SUBJECT: R. E. GINNA NUCLEAR POWER PLANT - AMENDMENT RE: CONTROL
ROOM EMERGENCY AIR TREATMENT SYSTEM ACTUATION
INSTRUMENTATION CHANGE (TAC NO. MB1887)

AMENDMENT NO. 83 TO FACILITY OPERATING LICENSE NO. DPR-18 GINNA NUCLEAR
POWER PLANT

SAFETY EVALUATION BY THE OFFICE OF NUCLEAR REACTOR REGULATION
RELATED TO AMENDMENT NO. 83 TO FACILITY OPERATING LICENSE NO. DPR-18
ROCHESTER GAS AND ELECTRIC CORPORATION
R. E. GINNA NUCLEAR POWER PLANT
DOCKET NO. 50-244

Figure 1. Radiation Monitoring System

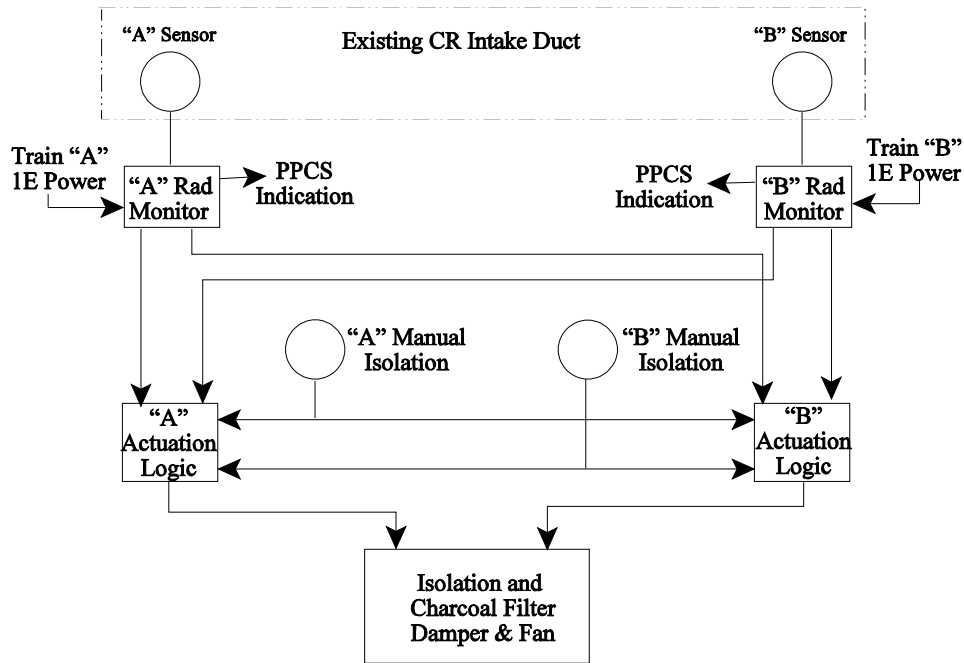
RG&E decided to replace the existing monitoring system with a pair of GM tube plenum probes, which would detect and measure the radiation within the 42-inch control room ventilation system air intake. The probes and associated monitors would be powered by two separate safety-related sources and would be configured into two redundant actuation logic trains, each with manual initiation. This style of monitor does not depend on a sample pump or any moving parts to accomplish its monitoring function, thereby providing increased system reliability (see Figure 1).

The present system employs only one particulate/iodine/noble gas (PING) monitor, which relies upon isokinetic sampling from the air intake duct (i.e., there is no redundancy in the present system). The ITS establish limiting values for the detected concentrations of particulate, iodine, and noble gas substances, and require control room isolation if a limiting value is exceeded.

The proposed system utilizes a single GM tube (per channel) instead of a PING monitor. The sensor will be located in the air supply duct. There is no sample line or pump, nor any of the active components used in support of a PING monitor. The GM tubes are designed such that the variation of the detector efficiency with photon energy closely matches the variation of exposure with photon energy. This design feature ensures that the importance of each photon is weighted correctly by the inherent efficiency of the detector. As a result the GM tubes and associated electronics are capable of measuring gross exposure over a broad spectrum of photon energies. GM tubes are typically calibrated in terms of equivalent dose rate, based on a referenced gamma photon energy and intensity.

Figure 2. System Block Diagram

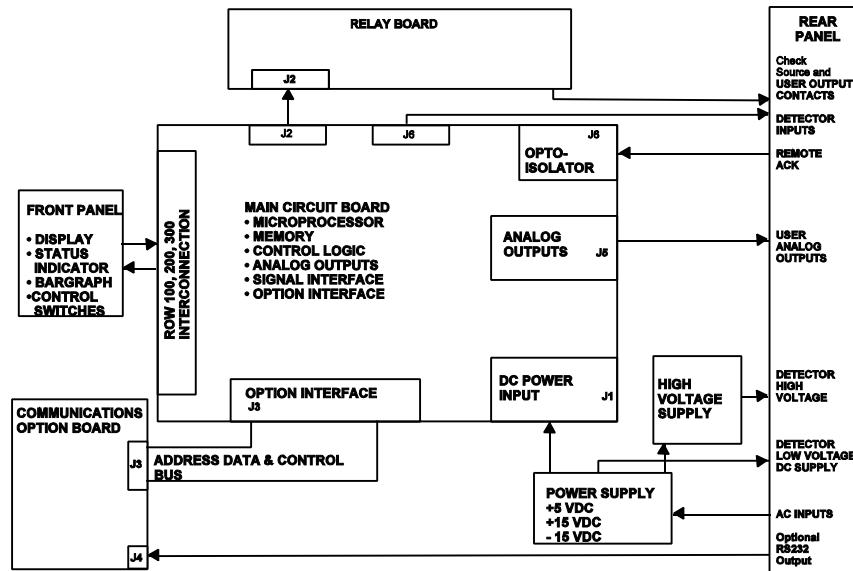
The Model 956A-201 UDR is composed of the following five circuit board assemblies mounted within the unit (see Figure 2):

The staff reviewed the hardware schematics (UDR Schematic Diagram, Drawing Number 942-200-13, dated August 6, 2002); and compared the schematics to the block diagram description in the Installation, Operation and Maintenance Instruction Manual (part number 955A-1, dated May 1996), the Design Specification (Universal Digital Ratemeter, dated December 21, 1983), Revision A of the Design Specification (dated February 1, 1984), and the Loop Diagram for Control Room Intake Monitor (Drawing Number S157033A-104, dated January 8, 2001). The staff found several minor typographical errors in the block diagrams, and the vendor has stated these errors will be corrected in the next version of the manual. The staff traced signals from sensor input to data and trip signal output through the schematics to determine which portions of the circuitry were used in both normal operation and in trip conditions.

Figure 3. Front Panel Display

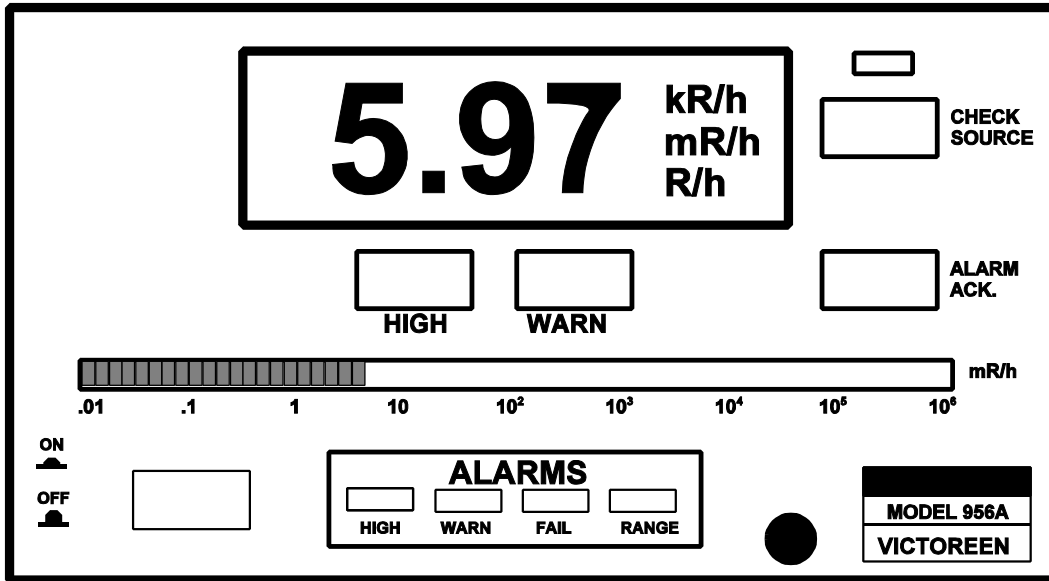
The front panel circuit board consists of the seven-segment display, backlights, status indicators, switches, and bargraph assembly (see Figure 3). The front panel interfaces to the main circuit board.
